# LiDAR Quality Assessment Report

Materials Received: 6/6/2012	Project Type: Partnership W/O Agreement
Project ID: SC_RichlandCo_2010	Project Description: Richland County, South Carolina, Collection Dates: 03/23/2010 - 03/27/2010
Project Alias(es):	Year of Collection: 2010

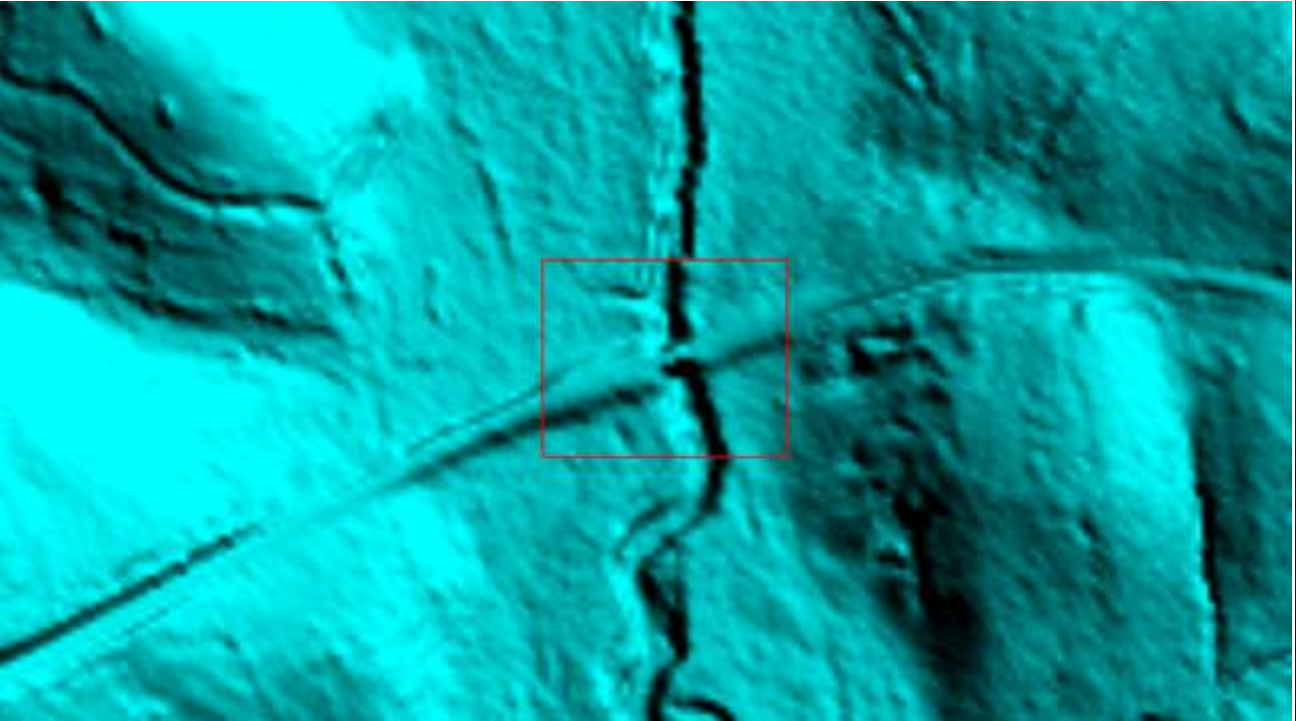
There are two bridges that were not removed from the Bare-Earth DEM. (Bridge\_Removal\_01)

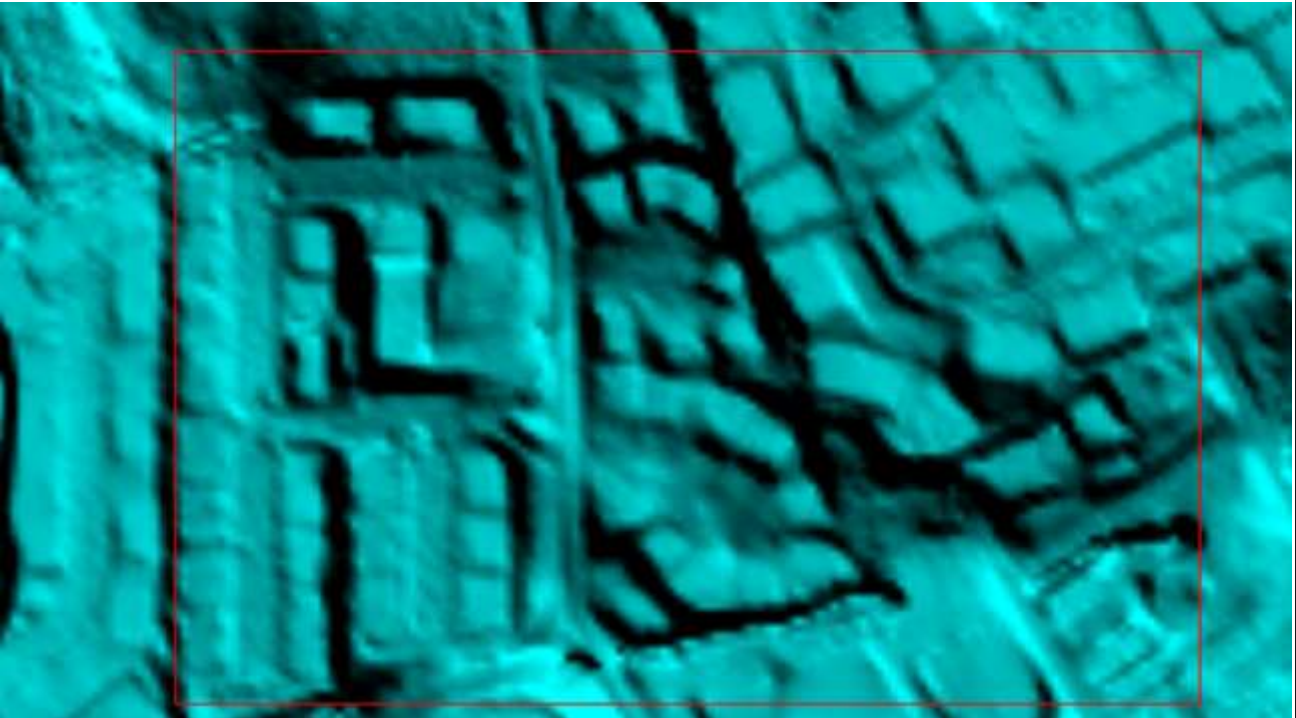
There are at least 9 areas where buildings were insufficiently removed from the Bare-Earth DEM. (Building\_Removal\_01)

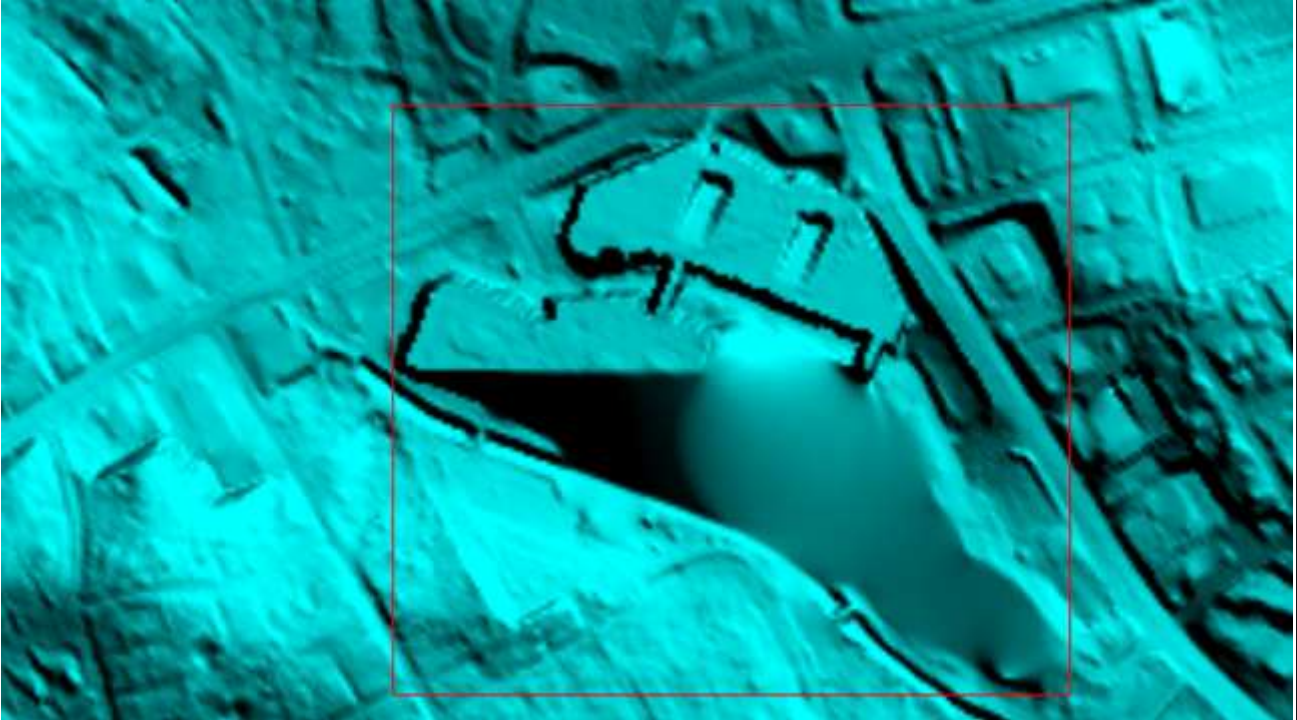
(Building\_Removal\_06)

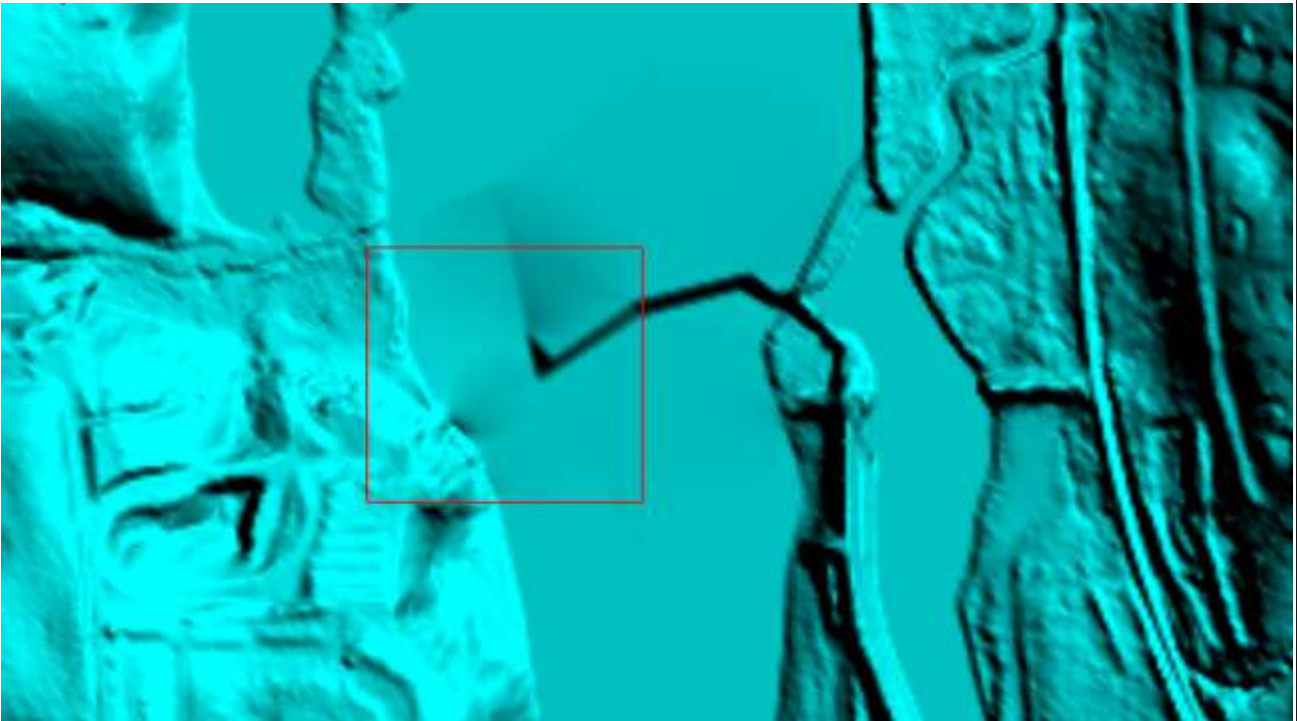
Part of a dam was removed improperly when the river was hydro-flattened. There is no indication that the dam was removed in reality. (Dam\_Removal\_01)

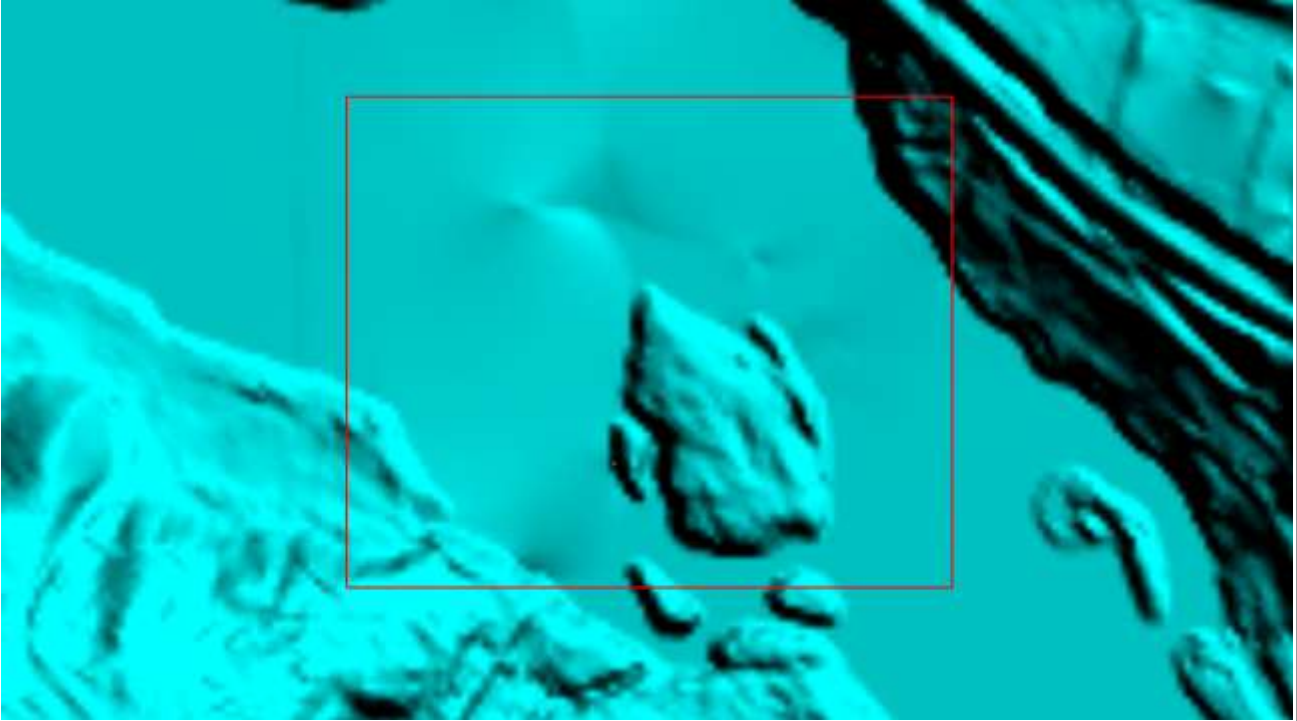
Hydro-flattening of the river is not flat in some areas, mostly surrounding large boulders or islands in the stream. (Lumpy\_Water\_01)

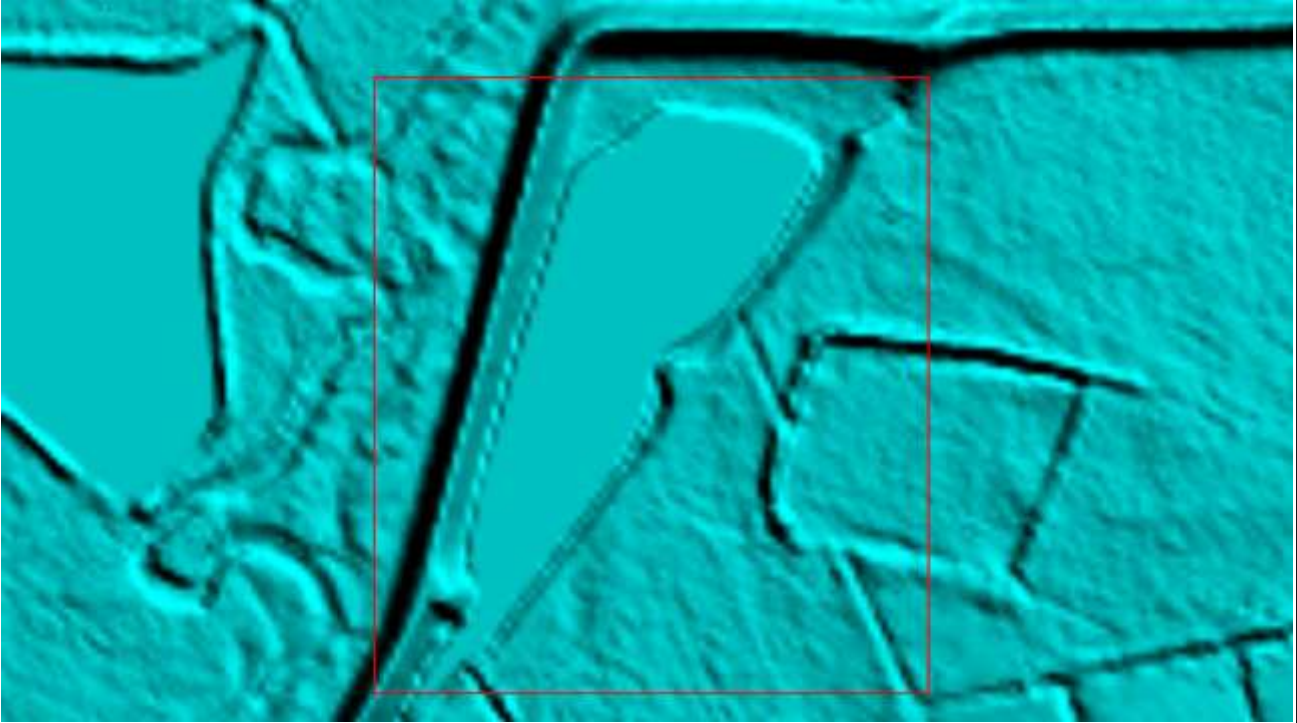
There was one area where the assigned water elevation is higher than the surrounding topography, giving the impression of floating water. (Floating\_Water\_01)

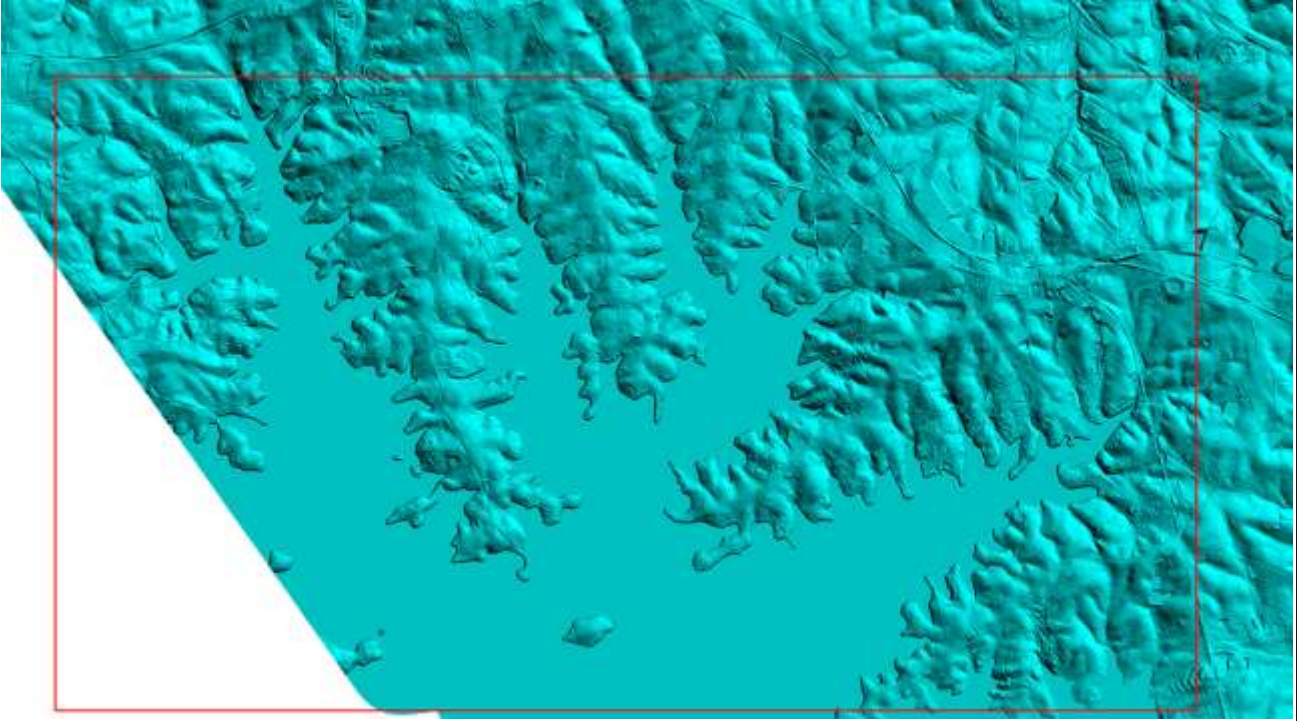
There are three areas where the assigned water elevation is substantially lower than the surrounding topography, giving the impression of steep drop-offs between the land and water surfaces. (Low\_Water\_02)

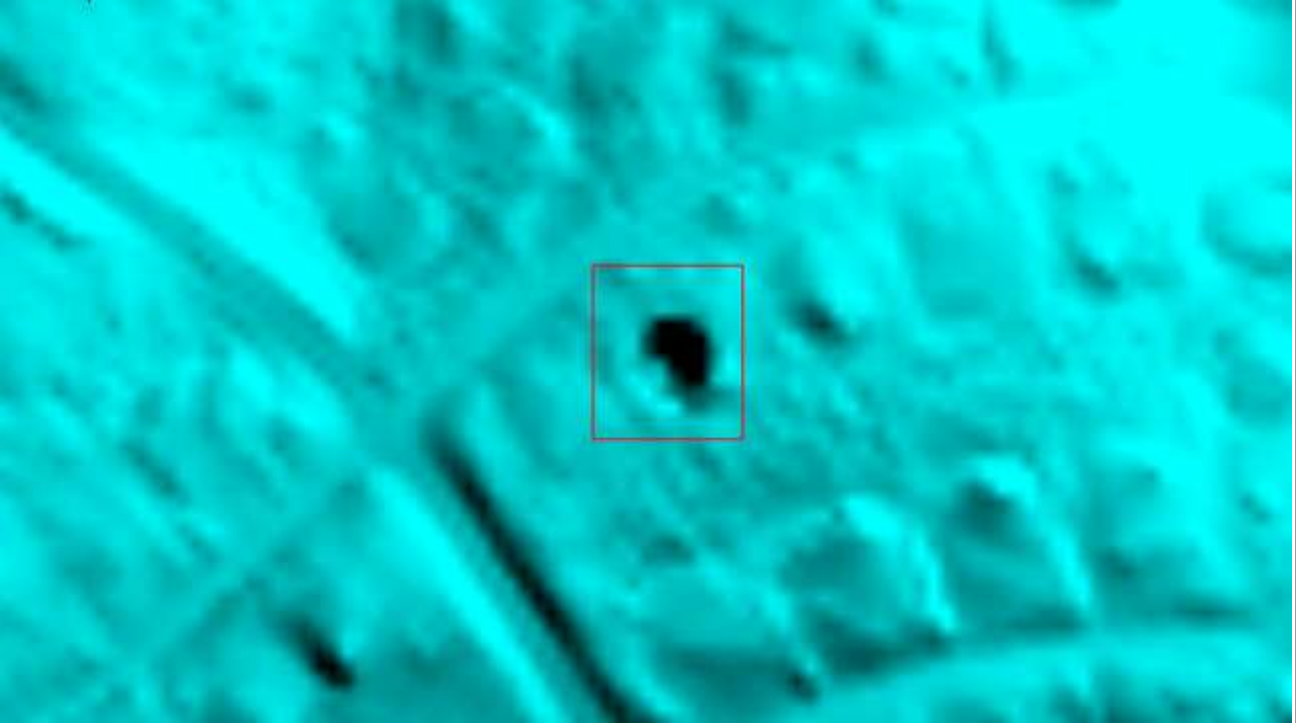
There are two small areas where there appears to be deep pits in places where buildings are indicated in multi-year satellite imagery. LAS also indicates buildings in these locations (Pits\_01)

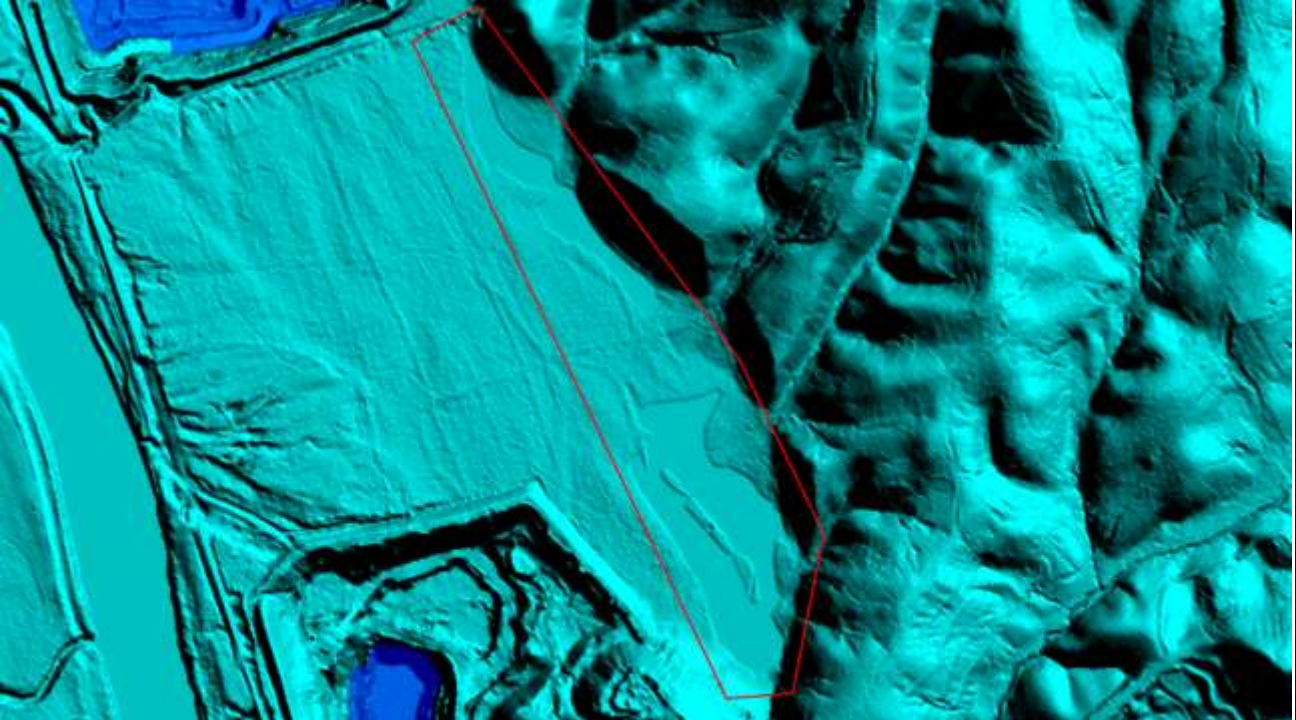
There are at least three areas where forested areas have been hydro-flattened. These are most likely intermittently inundated areas, and while not necessarily an error, they are being identified in this report for clarification. (Hydroflattened\_Forest\_01)

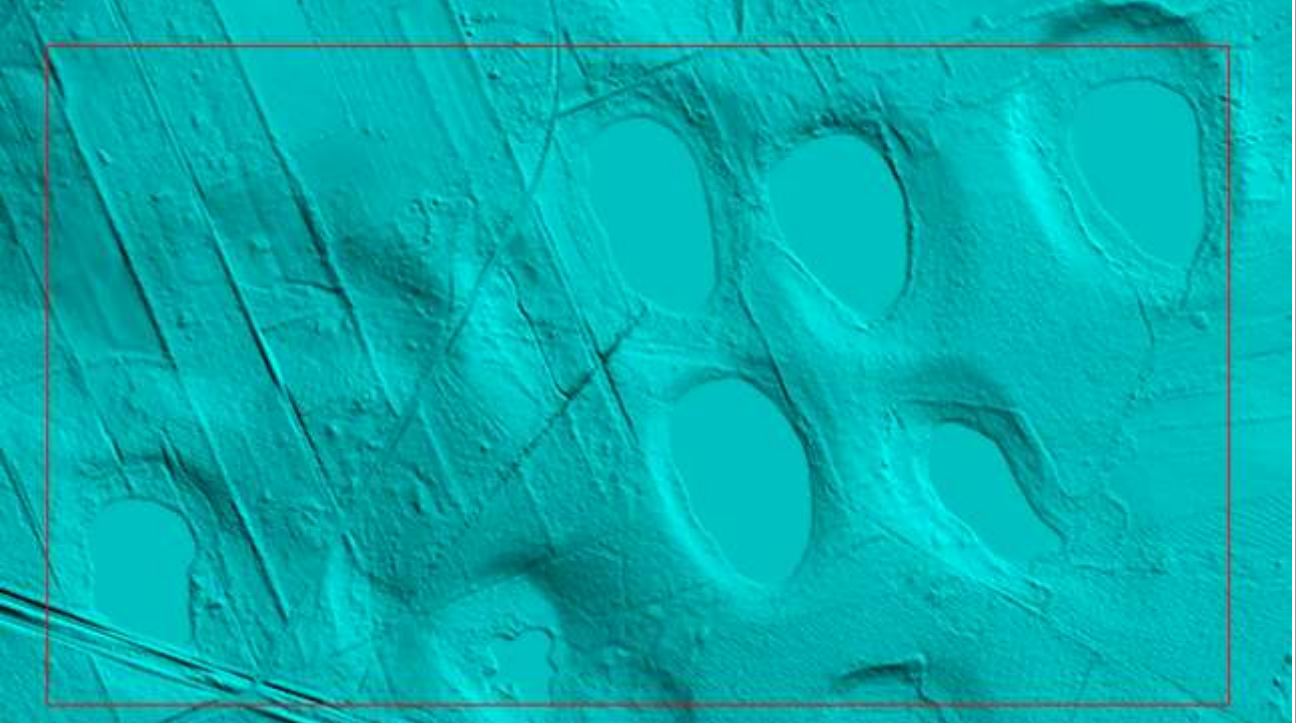
(Hydroflattened\_Forest\_02)
